**New Albany Architectural Review Board Meeting Agenda**  
Monday, April 13, 2026, 7:00 p.m.

**ARB-06-2026 Police Training Facility Certificate of Appropriateness and Waiver**

**New Albany Architectural Review Board**  
Monday, March 09, 2026 Meeting Minutes -DRAFT

HEALTHY NEW ALBANY FOOD PANTRY  
FINAL DEVELOPMENT PLAN  
CERTIFICATE OF APPROPRIATENESS

### Site Plan

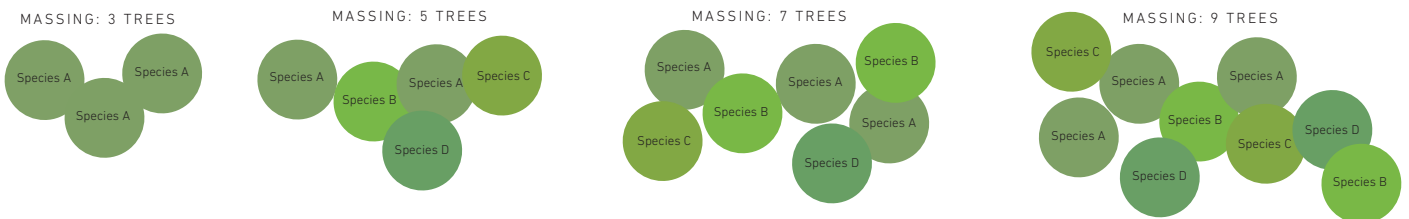
1. Update the proposed parking lot plans to include proper demarcation for proposed ADA spaces. Resubmit for review.
2. Update the proposed site plans to include site and parking lot lighting in accordance with City of New Albany standards. Resubmit for review.
3. Provide proposed grading for the on-site retention basin in accordance with City of New Albany standards. Resubmit for review.
